STAFF REPORT: 5/10/2023 REGULAR MEETING-**REVISED 5/4/2023** **PREPARED BY:** D. RIEDEN
APPLICATION NUMBER: #23-8326
VIOLATION NUMBER: 571
ADDRESS: 7840 VAN DYKE PLACE
HISTORIC DISTRICT: WEST VILLAGE
APPLICANTS/PROPERTY OWNERS: AMY HAIMERL, KARL ROYDEN KAEBNICK
DATE OF PROVISIONALLY COMPLETE APPLICATION: 4/17/2023
DATES OF STAFF SITE VISITS: 1/25/22, 4/27/23

SCOPE: DEMOLISH GARAGE, REPLACE DORMER SIDING (WORK COMPLETED WITHOUT APPROVAL)

Site photo 4, by Applicant, 2013: roof and dormer, showing asphalt roof and cedar shake siding

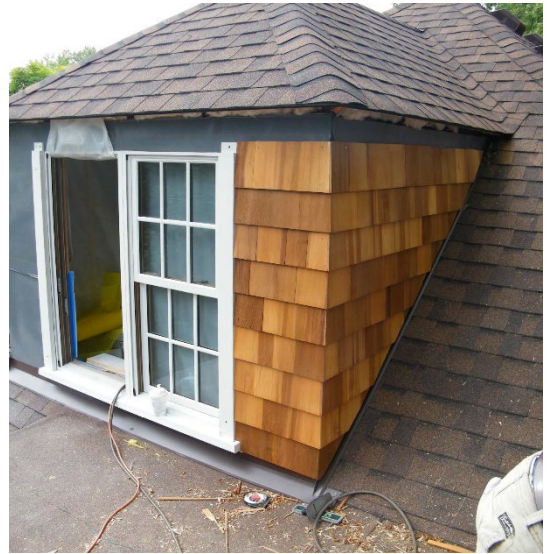
- It is the staff's opinion that the cedar shake shingle installation at the dormers and east elevation bump-out is of an appropriate material, design and scale and meets the historic district's Elements of Design.

- While the color of the asphalt shingle roof was changed from dark grey to a blend of brown and dark grey, it is the staff’s opinion that this replacement of materials is appropriate. (See Site photos 4)

Figure 1, Local Historic District Map, showing the green outline of West Village Historic District, the location of the former garage (red circle) and the surrounding context.

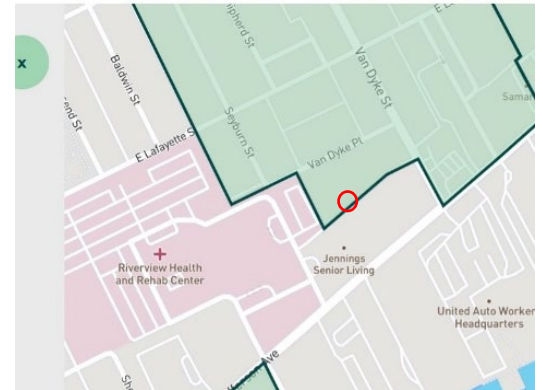
- The 1951 Sanborn map shows the presence of a one-story wood frame garage at the southeast property corner.
 - The Local Historic District map shows that the garage is at the very edge of West Village Historic District, across the alley from Jennings Senior Living's parking lot.
